One (1) copy of revision to Source Control Drawing 10-81000 "Dyna-Soar Ejection Seat and Survival System" dated March 16, 1962 (Unclassified)

SYM	DESCRIPTION	DATE	APPROVAL
D	<p>(1) Changed seat back boost position angle from 3 degrees aft to 2 degrees forward and called for adjustable upper arm supports to conform. (2) Revised sled test requirements to call out specific responsibilities and requirements, including heat shield in Appendix B. (3) Made The Boeing Company responsible for the lower half of the tube-cutter electrical disconnect and the pressure switch tube disconnect. (4) Called out rail hole size and rail end chamfer. (5) Called for safety pin in harness release handle. (6) Clarified "D" ring position in Figure 8.</p> <p>Reason: (1) Customer requested new seat back angle for boost. (2) through (6) Completion of basic design and drawing clarification. BO-2-0046</p>	<p>1/16/62</p>	<p><i>[Signature]</i></p> <p>Done 8-19 Feb 3/16/62</p>

DYNA-SOAR
EJECTION SEAT AND SURVIVAL SYSTEM

10-81000

EJECTION SEAT AND SURVIVAL SYSTEM ENVELOPE
FIG. 1

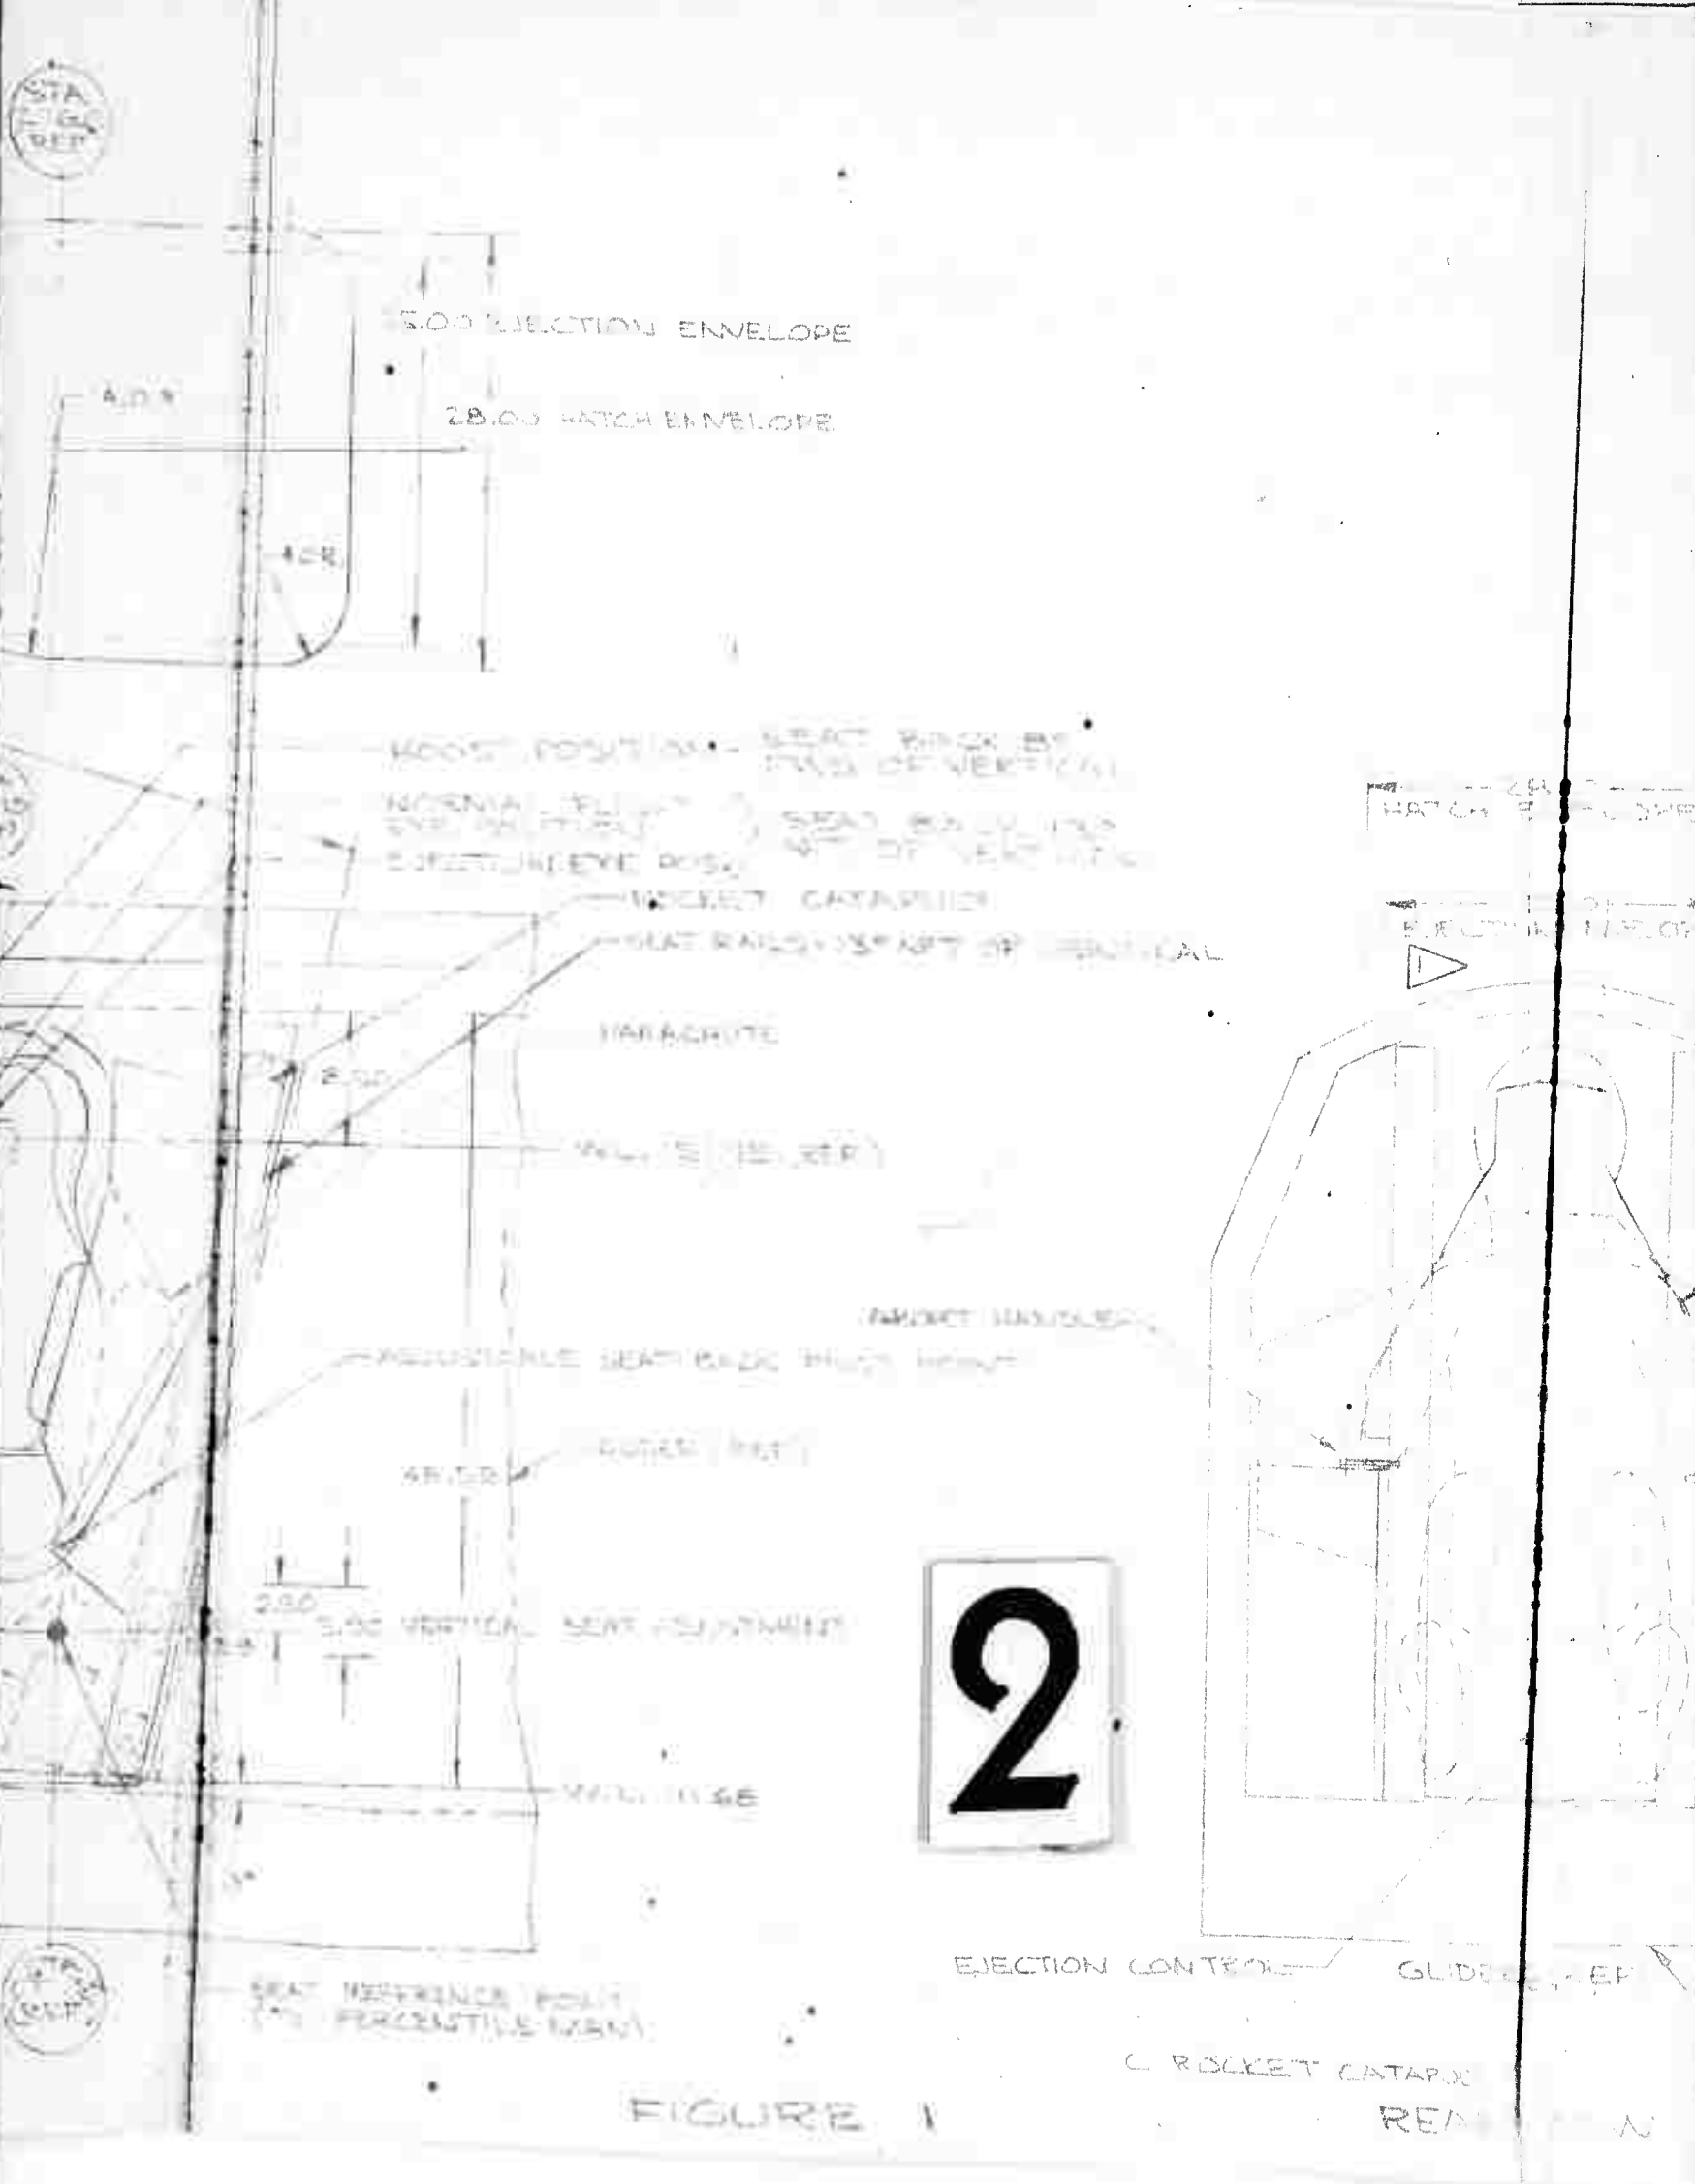
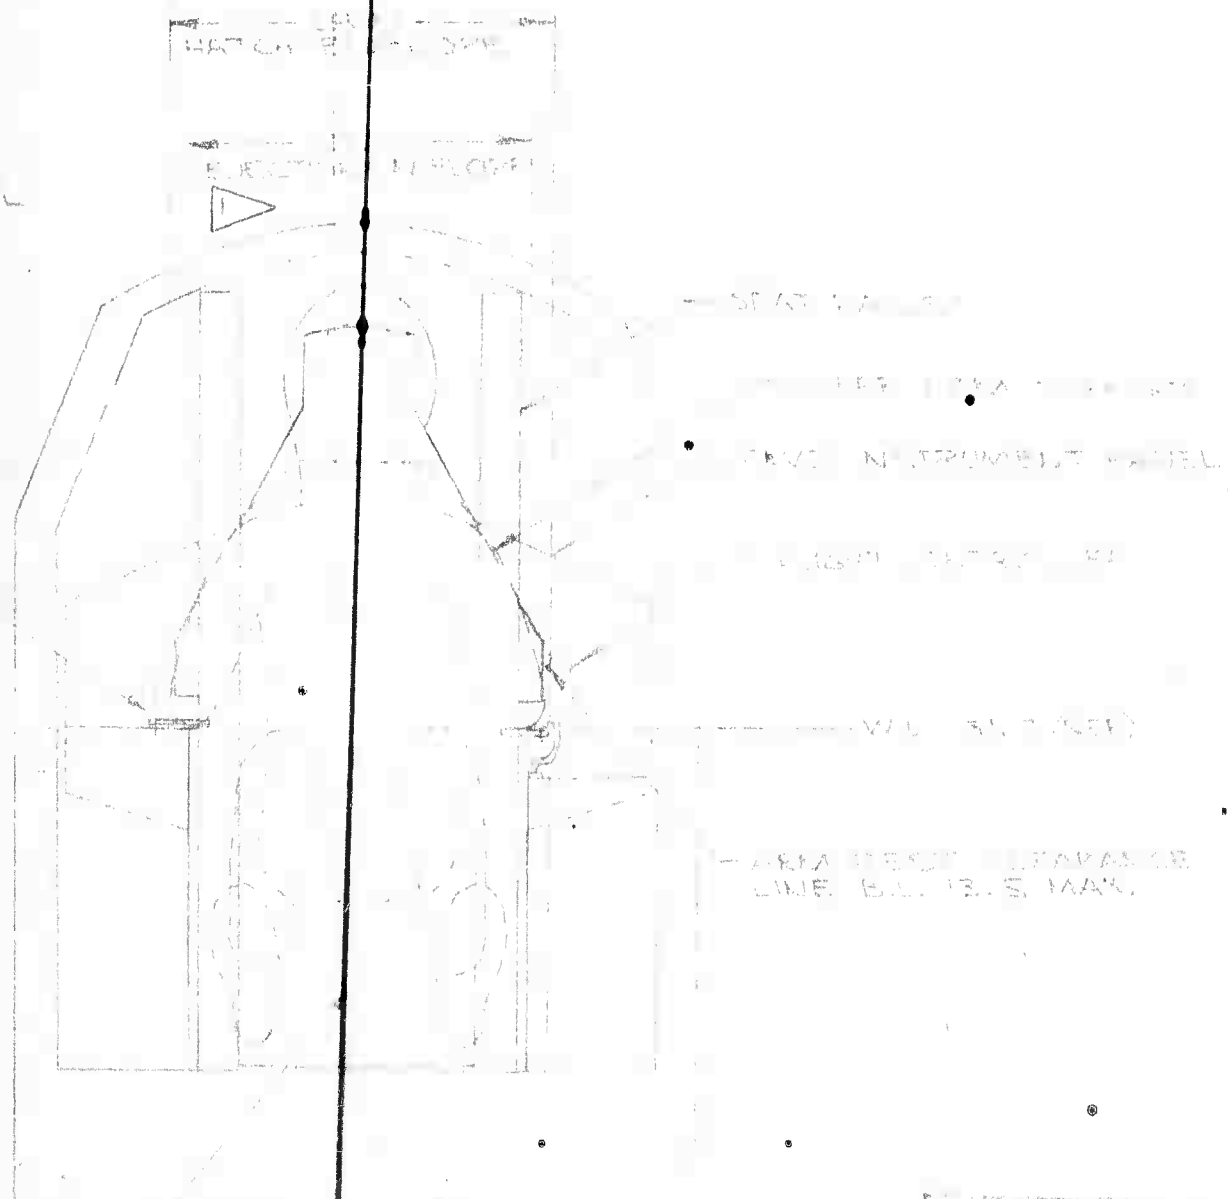
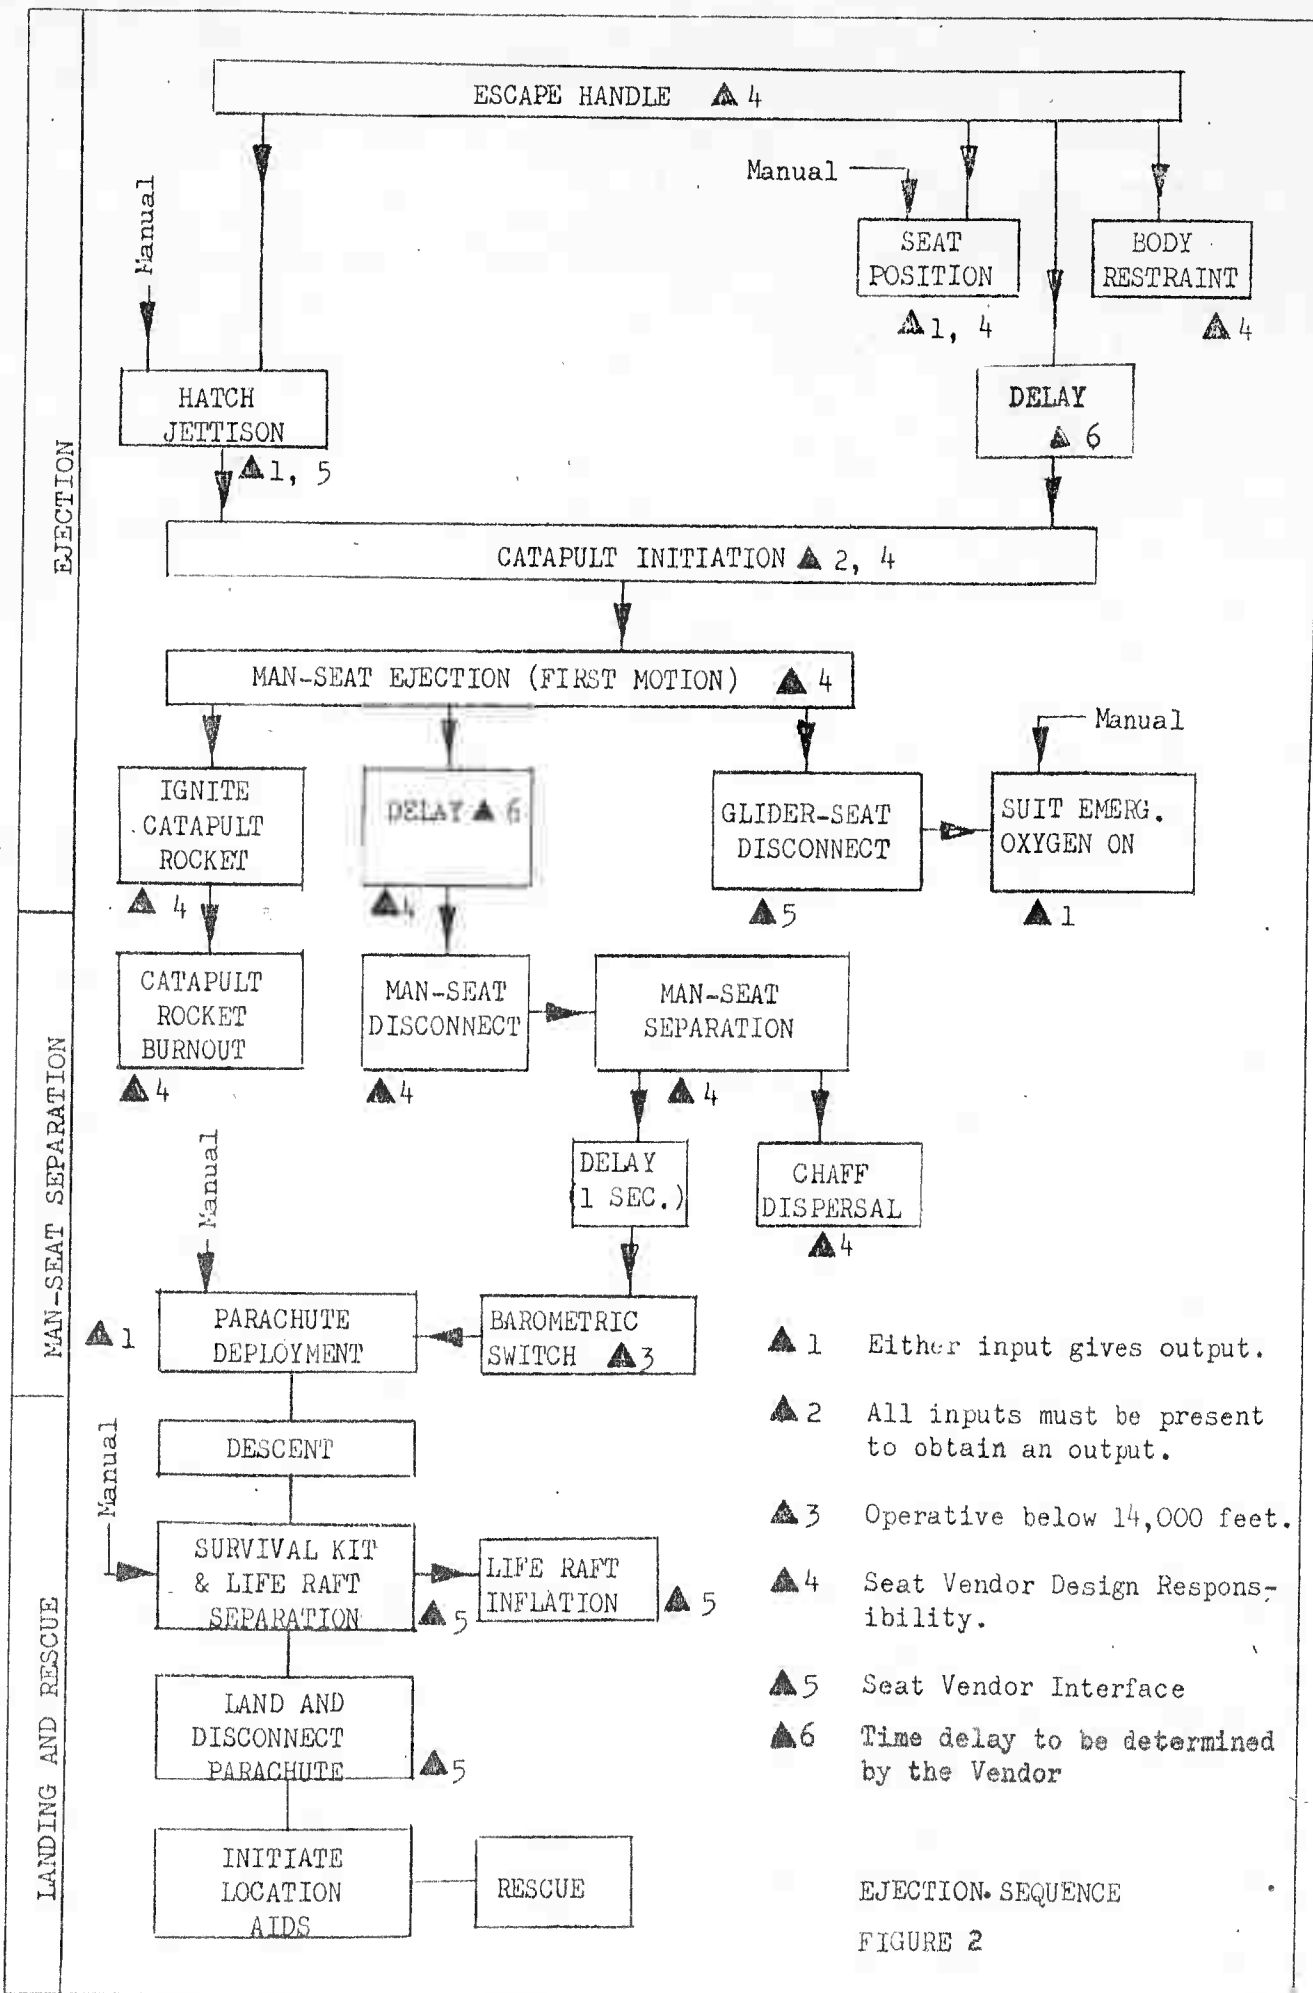
3.2.1 SEAT ADJUSTMENT. The seat shall be designed to provide vertical adjustment and seat back tilt adjustment. Vertical adjustment of the seat will not be required in flight, but will be a preflight operation on the ground. R
↓

3.2.1.2 SEAT BACK TILT ADJUSTMENT. The seat back shall be designed to provide manual seat back tilt positioning. The seat positioning lever or control shall be located on the top of the left hand side panel in a convenient and readily accessible position to the pilot or ground crew. Seat back tilt shall provide two positions with stops, namely; "Boost" position 2° forward of normal vertical, and "Ejection" position 13° aft of normal vertical, as shown in Figure 1. The flight position may be selected anyplace between the two positions at the pilot's option.

For the ejection sequence, the seat back shall be automatically power actuated to the ejection position and locked in place by a ballistic powered actuator or similar device. Electric powered actuators or devices shall not be used. This function shall be included in the seat pre-ejection sequence. Automatic seat back positioning may be incorporated into inertia reel design (paragraph 3.2.6) eliminating the need for a separate seat back positioning actuator. Positioning of seat back to the ejection position under forward accelerations (eyeballs in) shall not result in pilot injury of any kind. Failure of automatic pre-ejection seat positioning shall not prevent seat ejection. (See Figure 2.) R

3.2.10.1 UPPER ARM SUPPORT. Arm supports shall be provided on each side of the ejection seat back to provide maximum support to the upper arms of the pilot during boost. The arm supports must clear the 28 inch hatch envelope although they may exceed the nominal 25 inch ejection envelope. The arm supports shall be adjustable for 1.00 inch forward and one inch aft at the nominal position. The adjustment shall be designed such that the top and bottom ends may be moved throughout the adjustment either jointly or separately. See Figure 1, page 23.
